**PCO #038**

**Project:** 21-501 - Collin County Adult Detention Facility, Phase 1 Addition  
 4300 Community Avenue  
 McKinney, Texas 75071

**Prime Contract Potential Change Order #038: PR #9R Future Ductwork and Raceways at Female Shell Out Space**

**PROJECT:** Collin County Adult Detention Facility **PROPOSAL REQUEST 09R**  
4300 Community Avenue  
McKinney, TX 75071

**1 LEVEL 1 EAST FLOOR PLAN - DUCTWORK**  
1/8" = 1'-0"

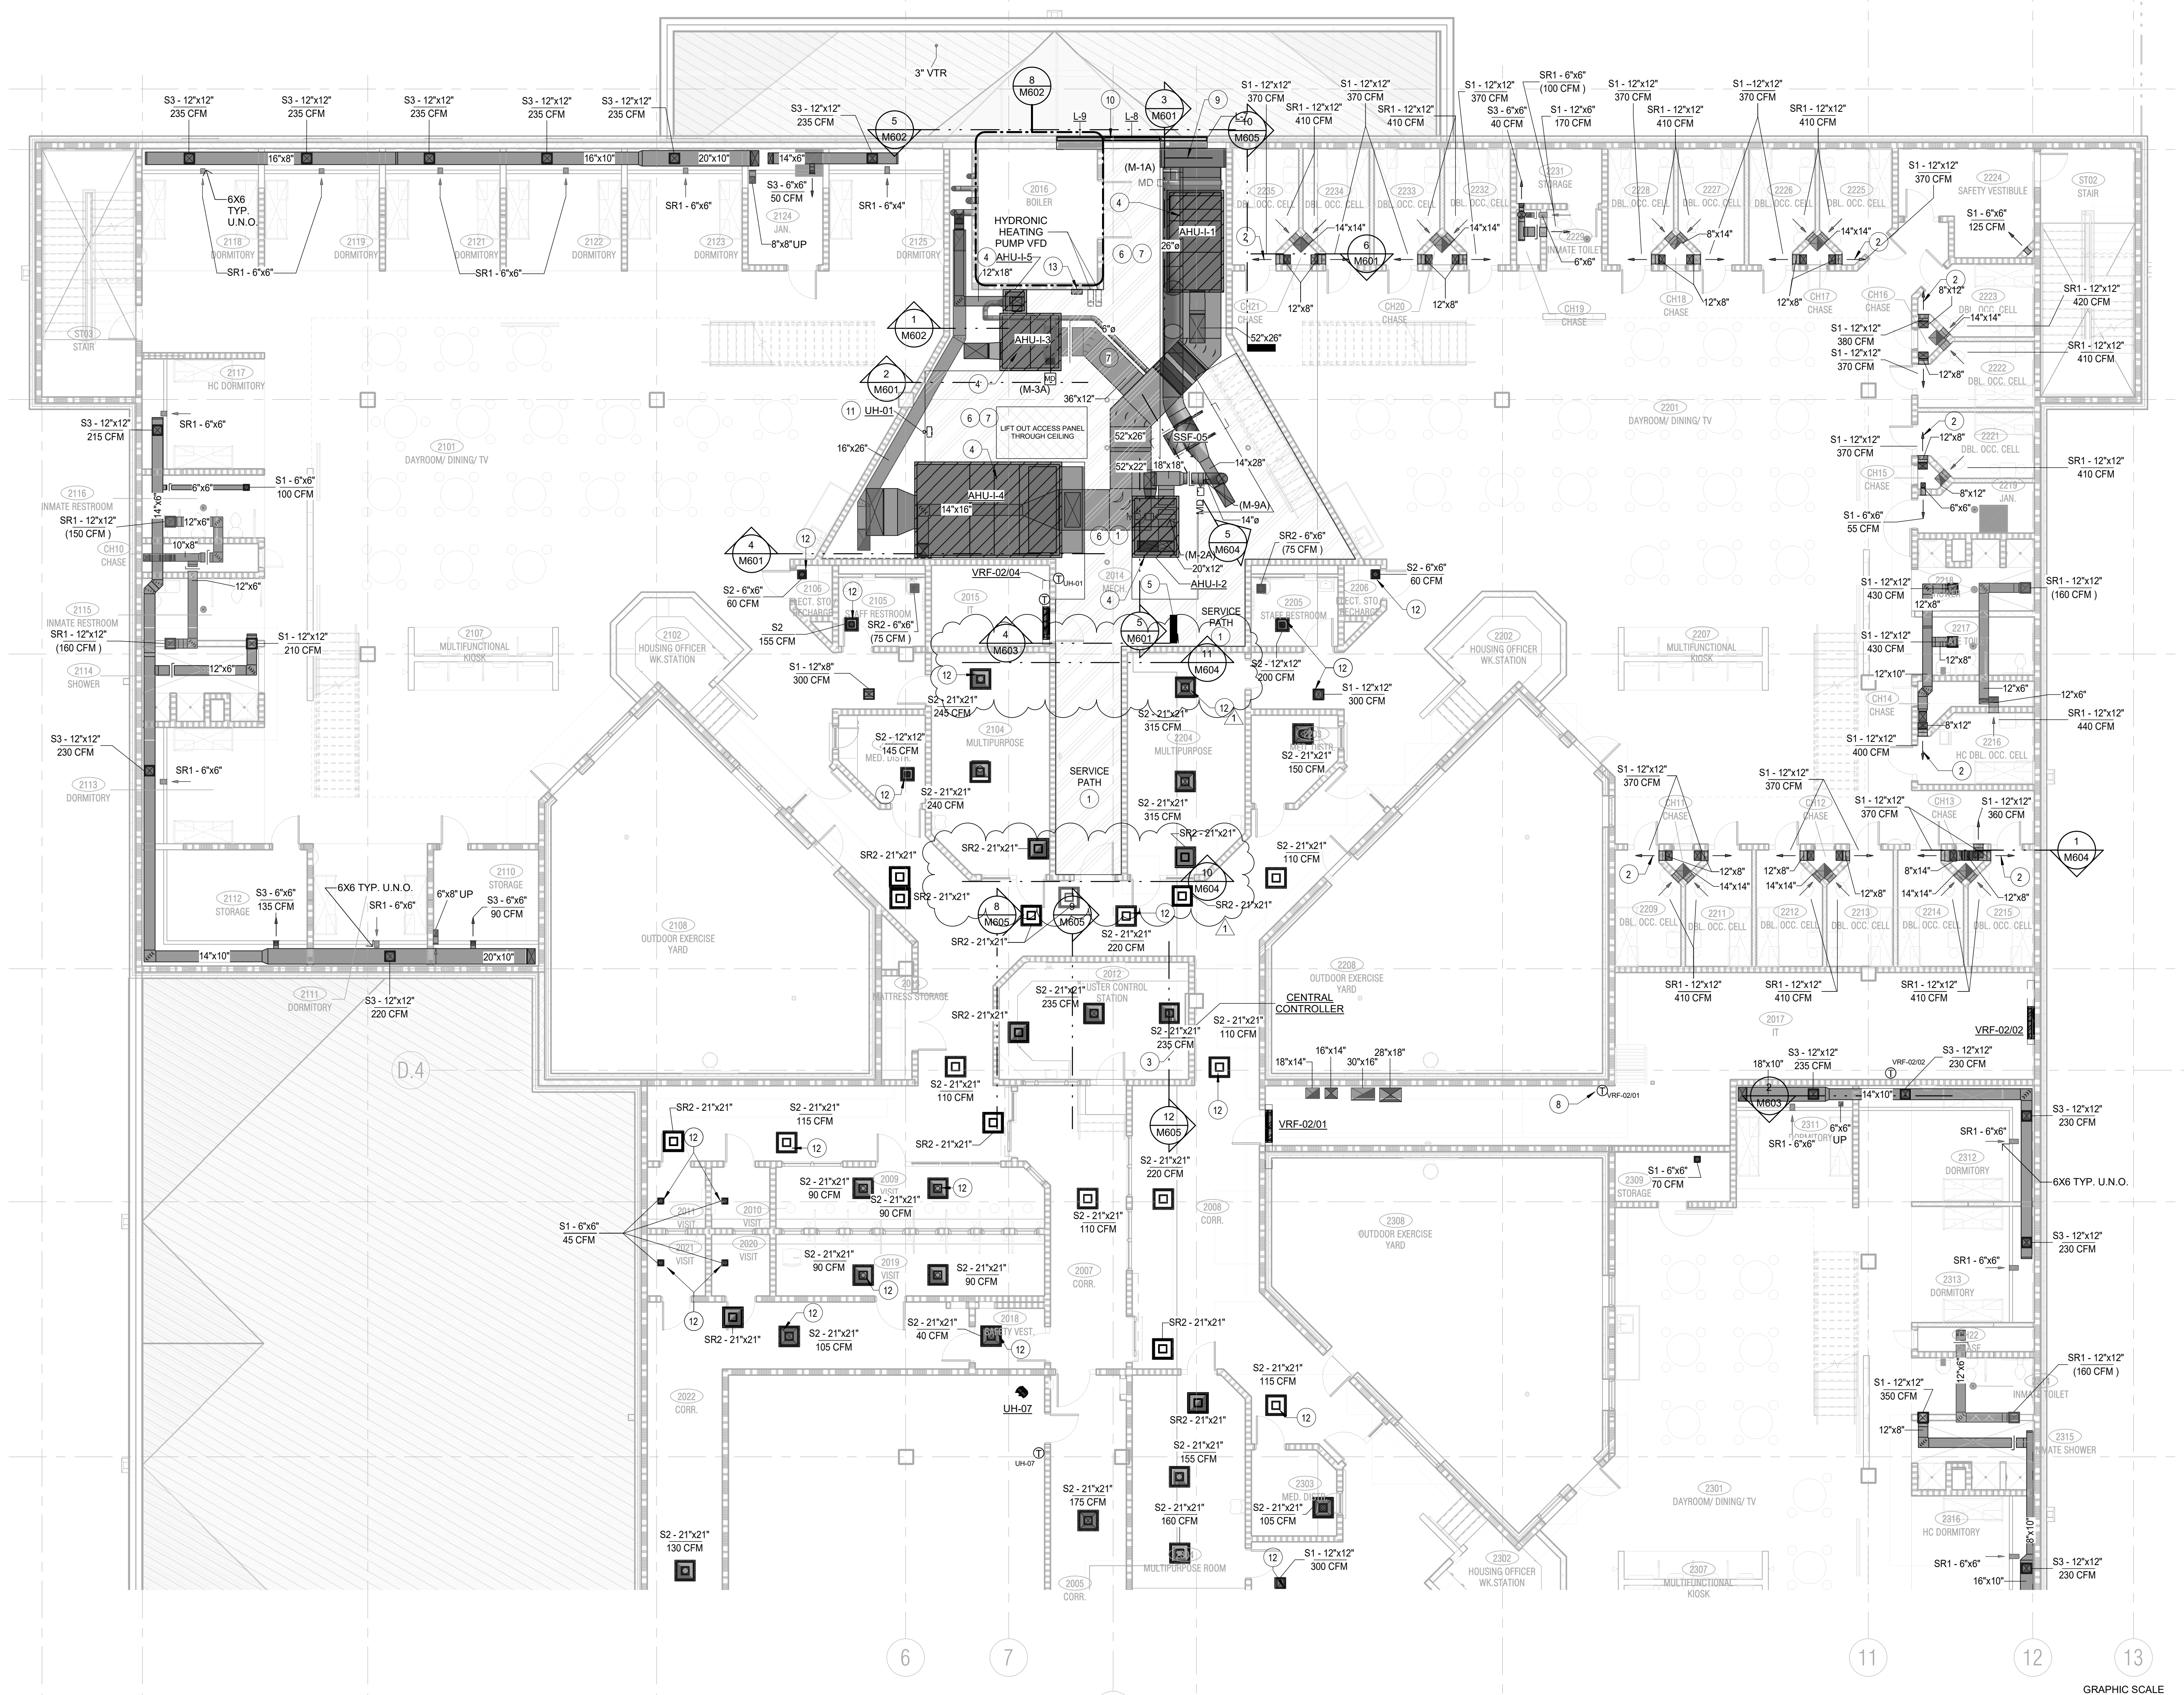
- INSTALL HEATER AHAP.
- REFER TO M221 FOR CONTINUATION. TYPICAL ALL DIFFUSERS/GRILLES WITHIN SPACE.
- HYDRONIC HEATING BOILER CONTROL PANEL.

**1 LEVEL 1 WEST FLOOR PLAN - DUCTWORK**  
1/8" = 1'-0"

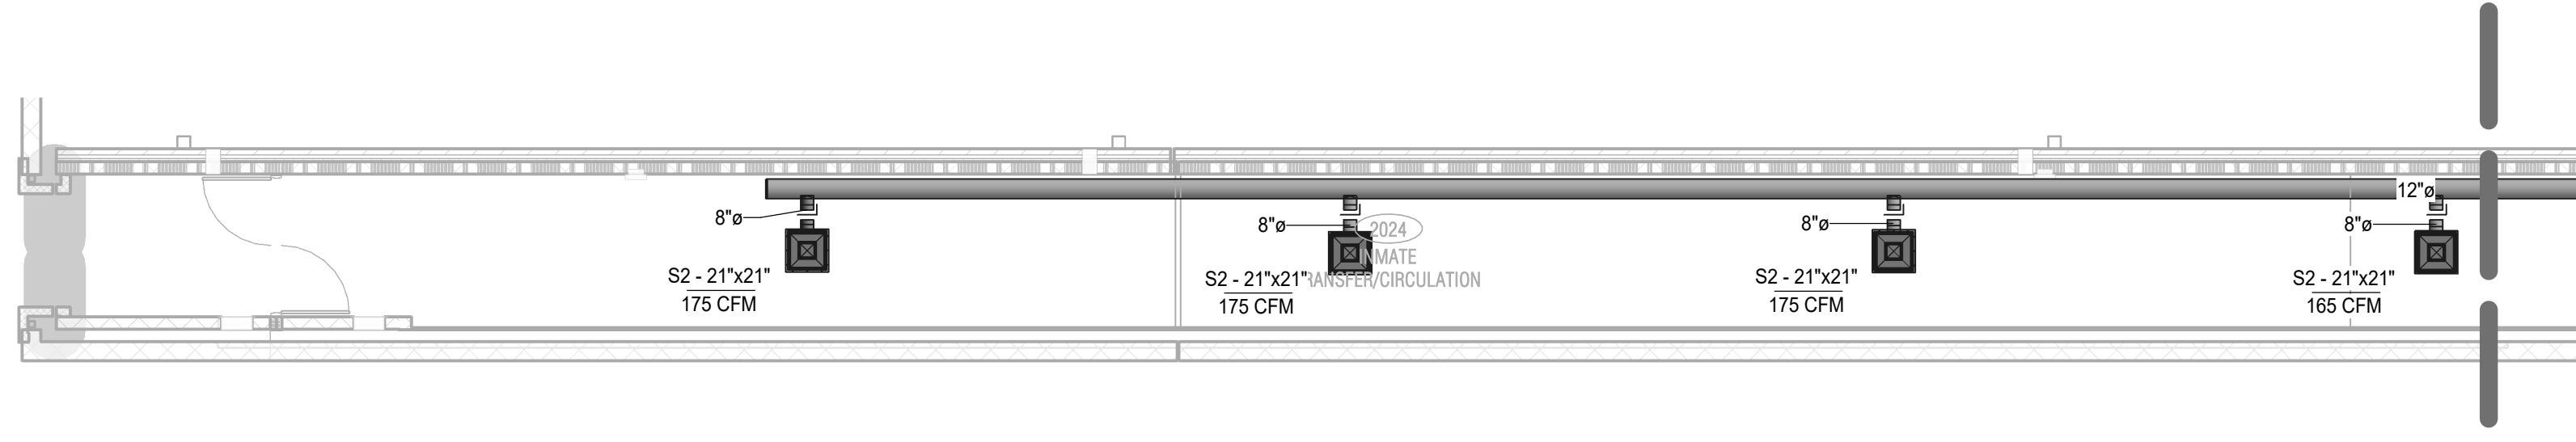
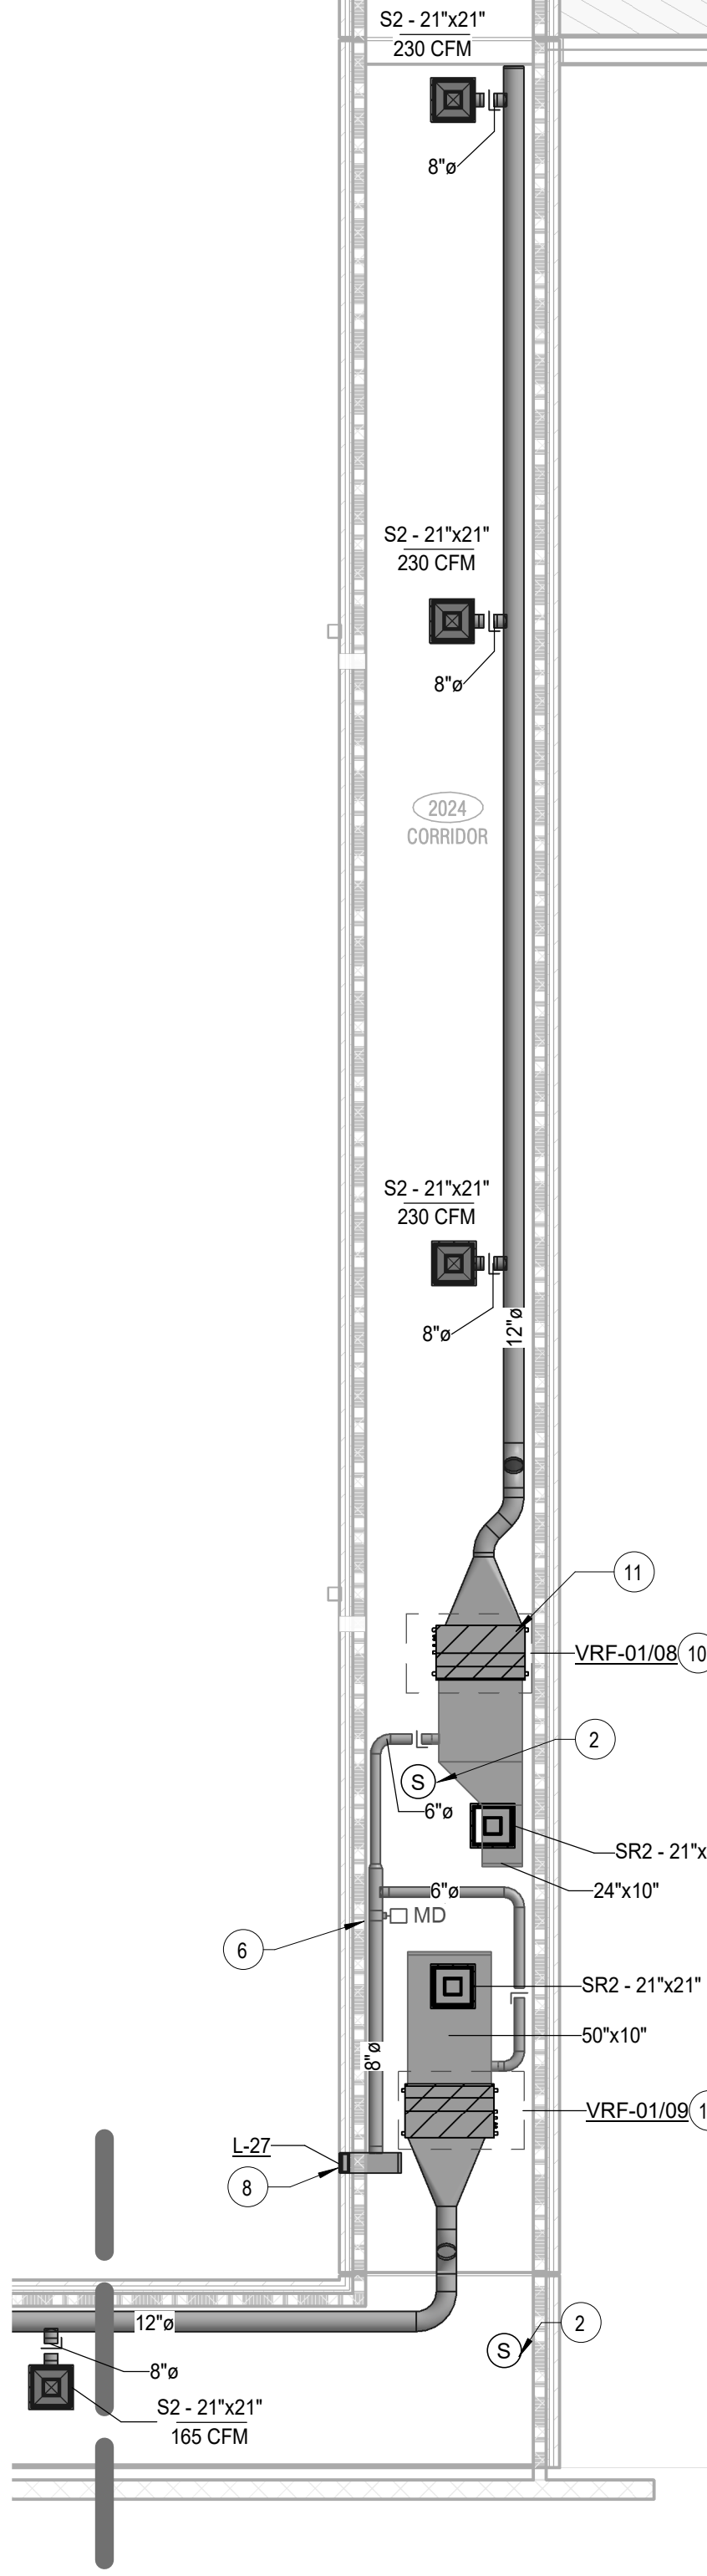
- PROVIDE THERMISTOR IN SUPPLY DUCT OF VRF DUCTED UNIT. THERMISTOR SHALL BE MAPPED BACK TO BAS. TYPICAL ALL DUCTED VRF UNITS.
- SUPPLY DUCT FOR FUTURE AHU TO BE INSTALLED AS HIGH AS POSSIBLE (AHAP). RETURN DUCT FOR FUTURE AHU TO BE INSTALLED BELOW SUPPLY. CAP ON ENDS FOR FUTURE CONNECTION. PROVIDE SECURITY BARRIER AS REQUIRED AND AT PENETRATION TO ALTERNATE #1. EXTEND DUCT 36" INTO ALTERNATE #1 AND CAP FOR FUTURE CONNECTION.

1 TIER LEVEL EAST FLOOR PLAN - DUCTWORK
1/8" = 1'-0"

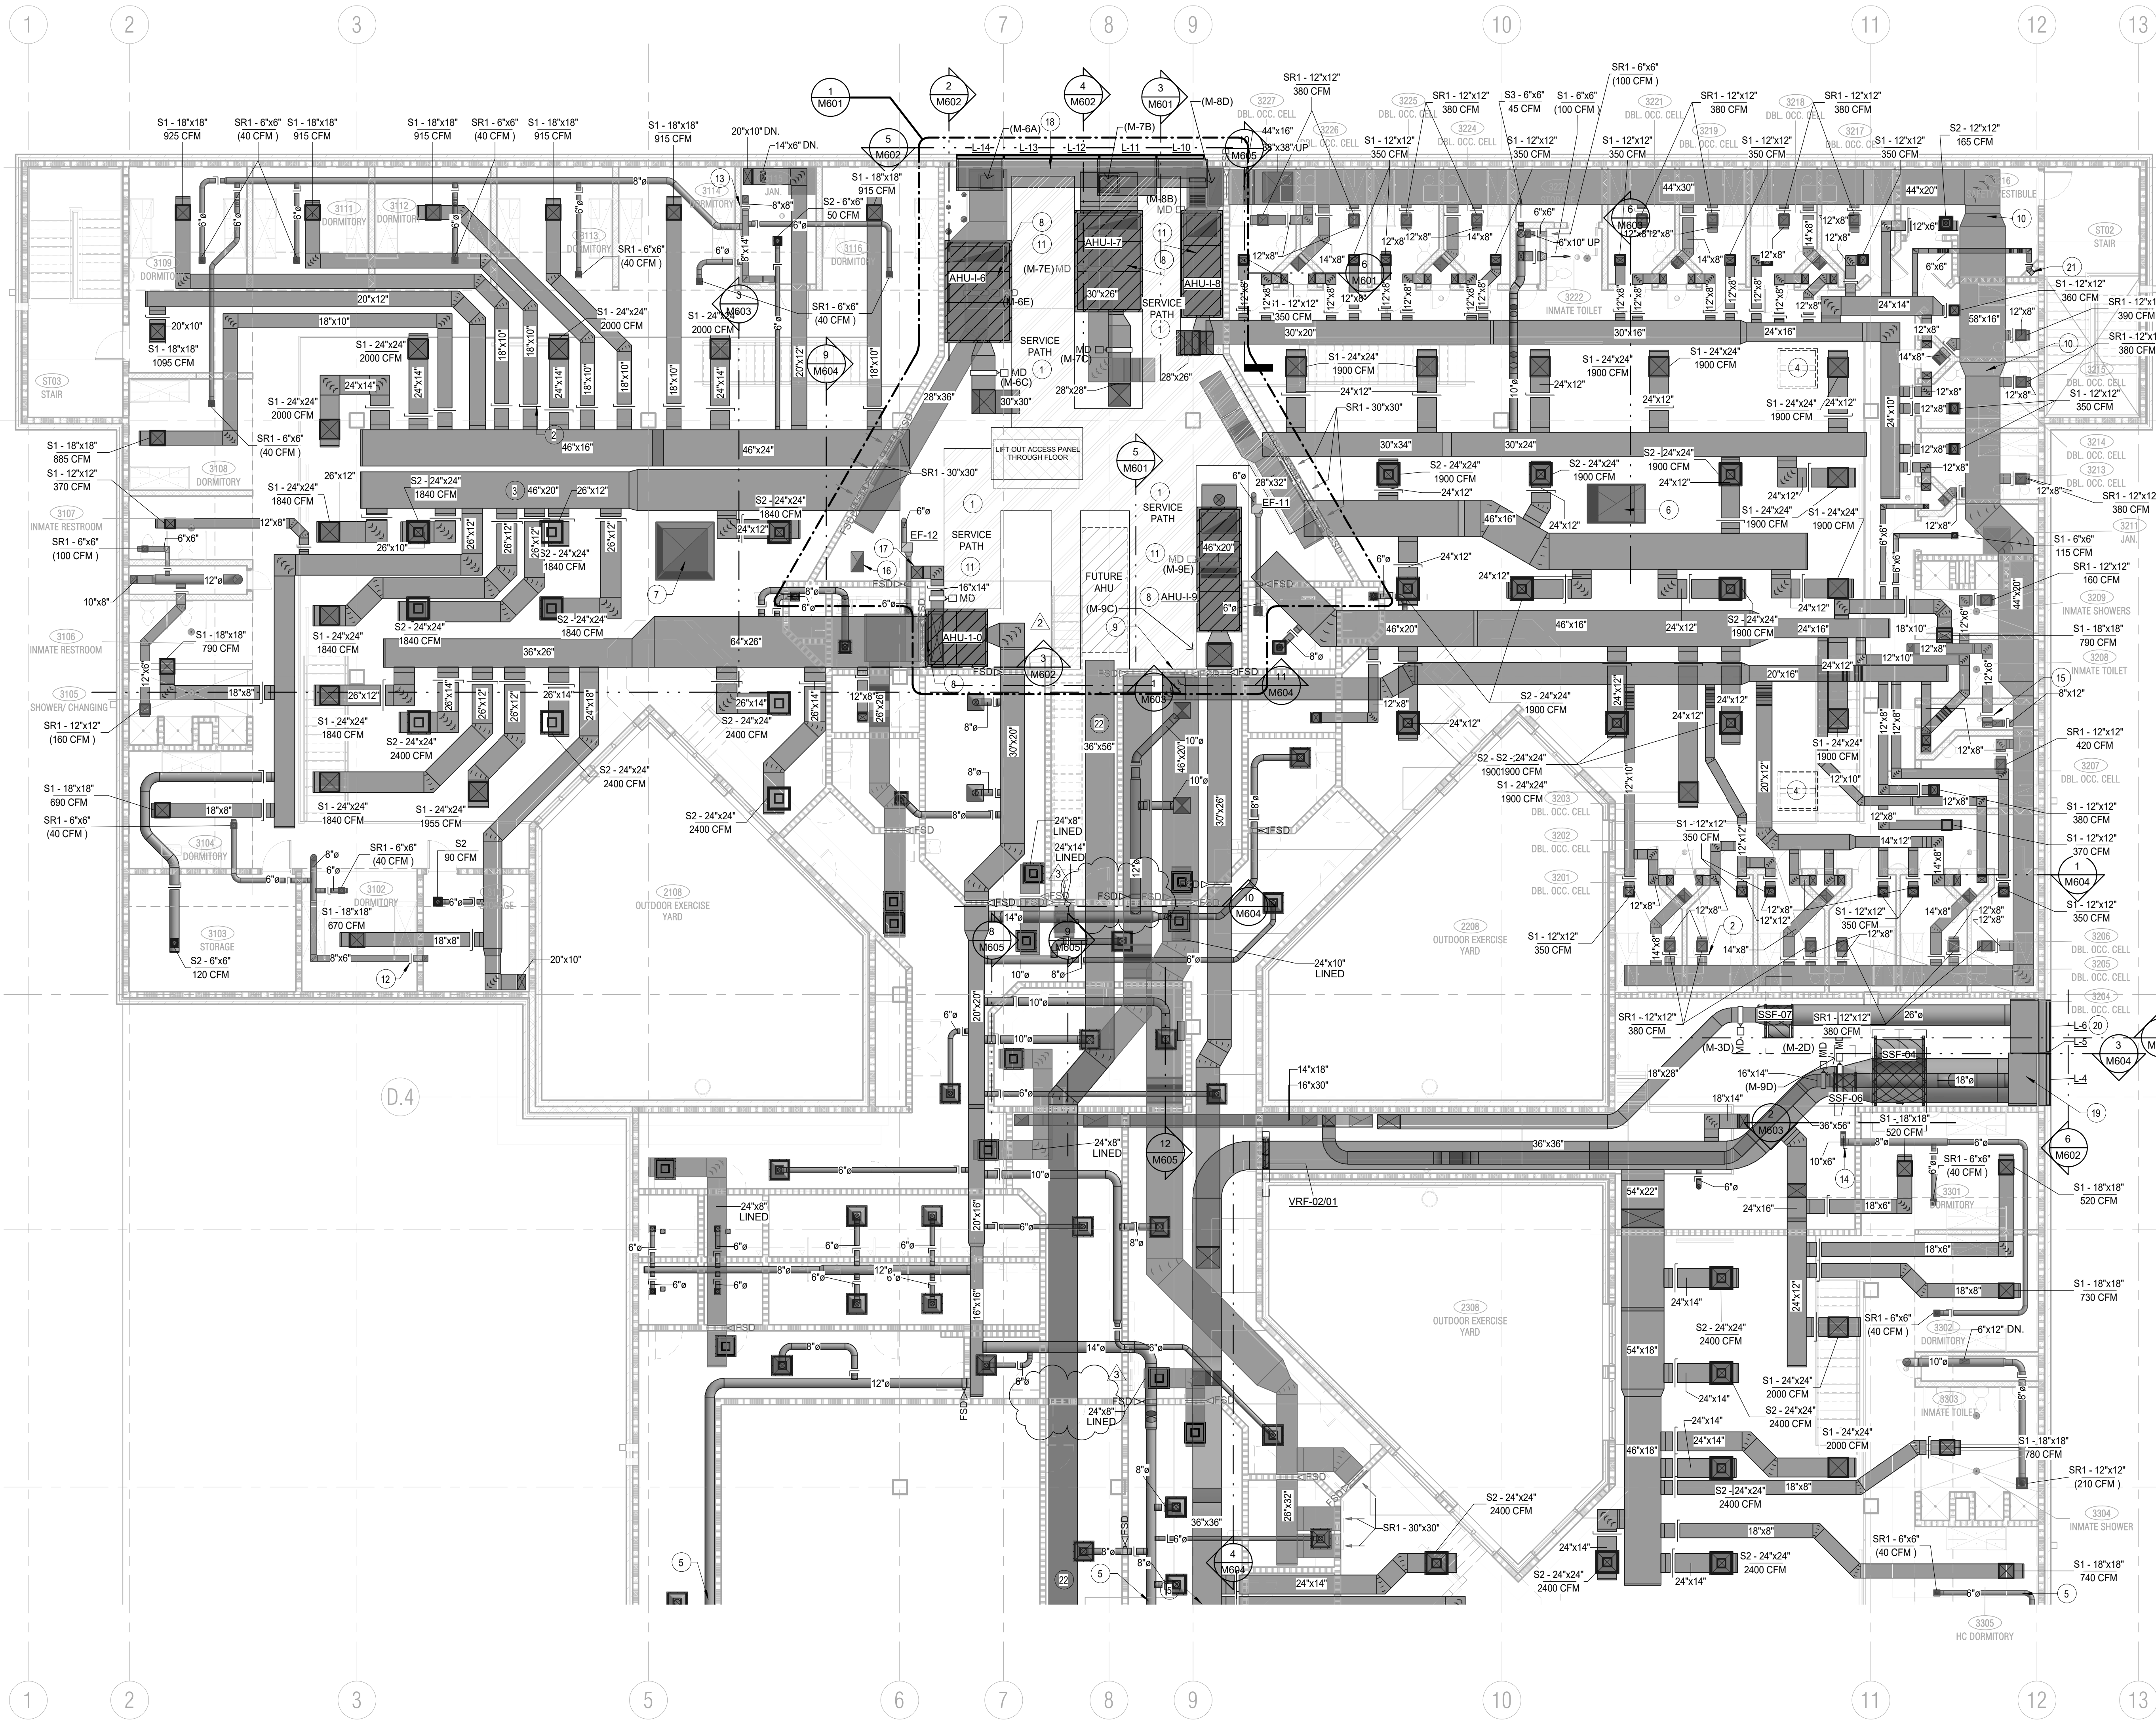
11 SERVICE PATH SHALL BE WIDE ENOUGH TO ALLOW FOR ADJACENT UNITS TO BE SERVICED. PATH WIDTH SHALL BE AT MINIMUM THE WIDEST COMPONENT IN ADJACENT EQUIPMENT.
12 BALANCE EXHAUST DAMPER TO 120 CFM.
13 BALANCE EXHAUST DAMPER TO 240 CFM.
14 PROVIDE DAMPER IN 6X6 DOWN TO FLOOR BELOW. BALANCE EXHAUST DAMPER TO 120 CFM.
15 BALANCE EXHAUST DAMPER TO 160 CFM.
16 26X16 EXHAUST TP TO ROOF.
17 OUTSIDE AIR UP. REFER TO D1/M601 FOR CONTINUATION.
18 PROVIDE INSULATED PLENUM. DEPTH SHALL BE A MINIMUM OF 36".
19 PROVIDE INSULATED PLENUM COMMUNICATING L-4 & L-5. DEPTH SHALL BE A MINIMUM OF 36".
20 PROVIDE INSULATED PANEL ON BACK SIDE OF INACTIVE SECTION. LOUVER SHALL BE REMOVABLE AND USED FOR ACCESS PATH FOR EQUIPMENT MAINTENANCE.
21 DUCT TO TERMINATE IN OPEN CHASE TO FLOOR BELOW. SEE FLOOR BELOW FOR FLOWRATE OF BALANCING DAMPER.
22 SUPPLY DUCT FOR FUTURE AHU TO BE INSTALLED AS HIGH AS POSSIBLE (40"AP). RETURN DUCT FOR FUTURE AHU TO BE INSTALLED BELOW SUPPLY. EXTEND DUCT INTO MECHANICAL ROOM AS SHOWN AND CAP ON ENDS FOR FUTURE CONNECTION. DUCT SHALL BE EXTENDED A MINIMUM OF 36" INTO MECHANICAL ROOM.
